Location Address: GRIFFIN ROAD & SW 40TH AVE.

Explanation of Request: Preliminary Site Plan Proposed 5,411 SF Convenience Store with 20 fuel positions

**Re: Site Plan review for a service station (Racetrac).
File number 18-DSP-62**

The following is a response to staff comments. Below are the comments along with our responses in bold:

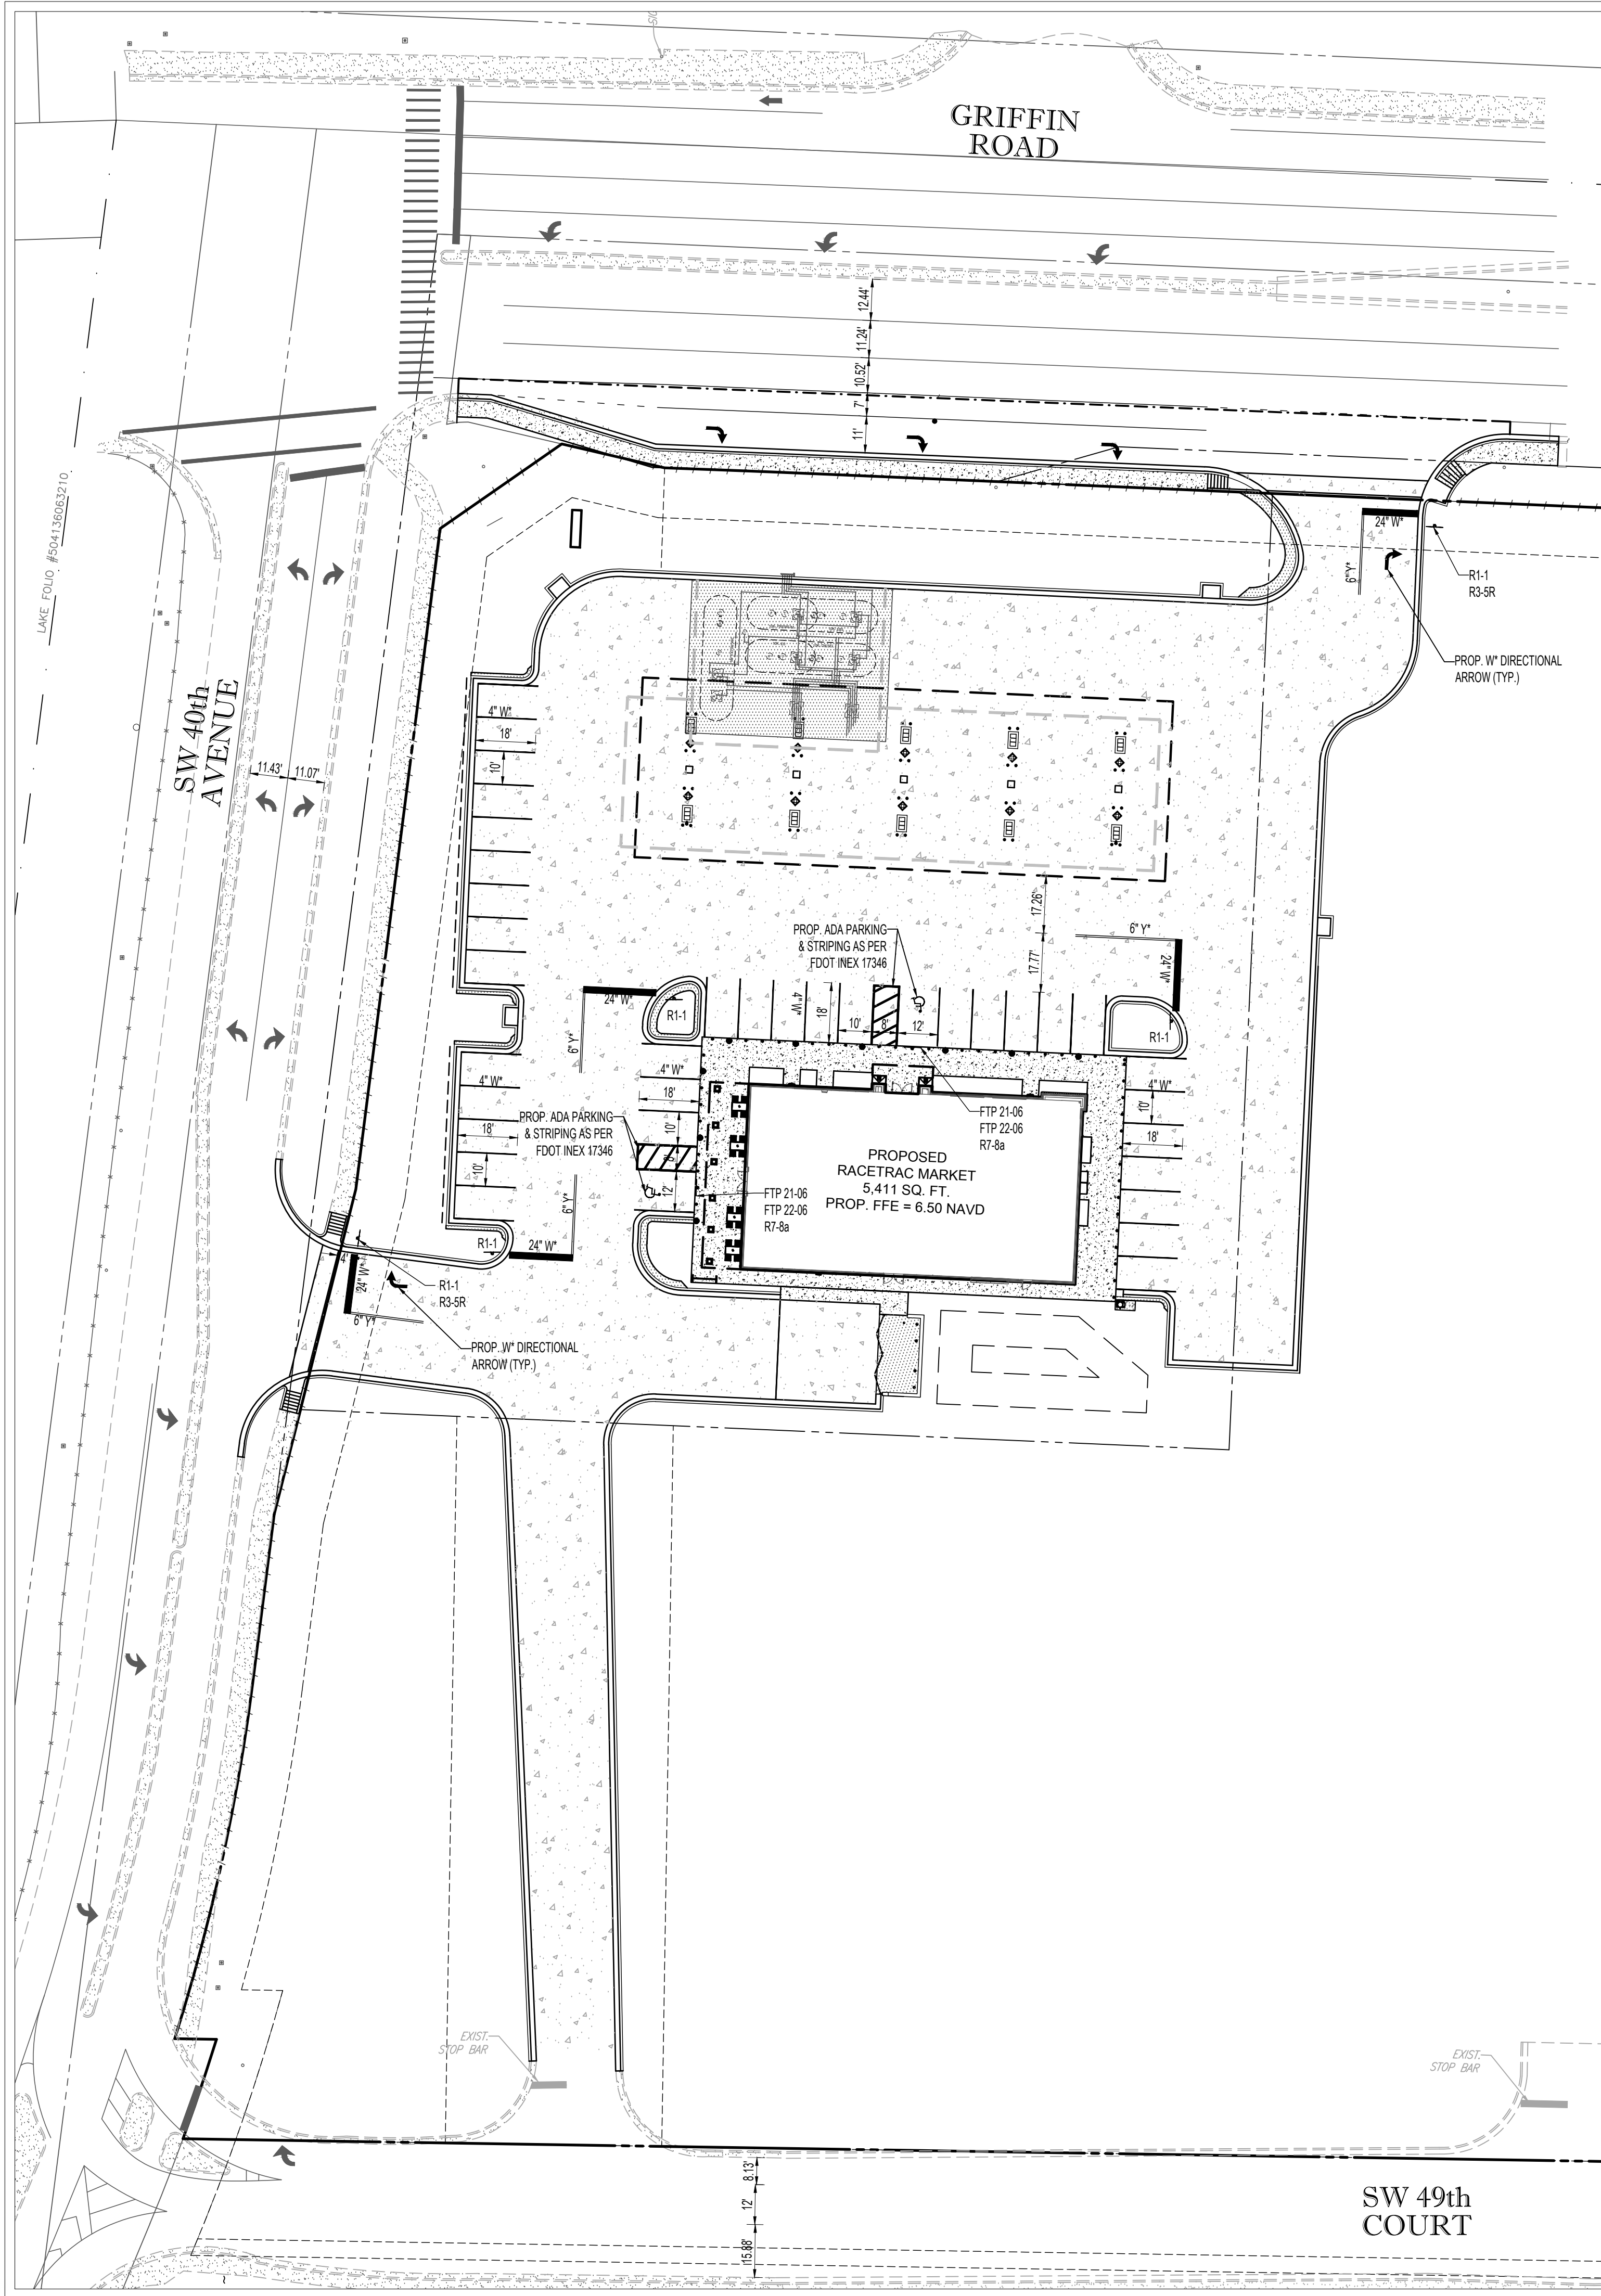
6. Provide separate pavement markings and signage plan.

12. It is requested that a separate detailed conceptual drawing showing only the existing and proposed traffic control devices (signing, pavement markings, laneage, lane use/widths, turning / corner radii, sight distance triangles, etc.) on the roadway network surrounding and within the site (ingress/egress) be provided. The existing means of illustrating these elements as shown on Sheet No. C-1.1 lacks detail and contains too much unrelated information to accurately review. Dimensions for all signing, pavement markings, radii, lane width/length, etc. should also be included.

Response: See PMS Plan on sheet C1.3.

Response: A Pavement, Marking & Signage (PMS) Plan has been provided. Please refer to sheet C1.3.
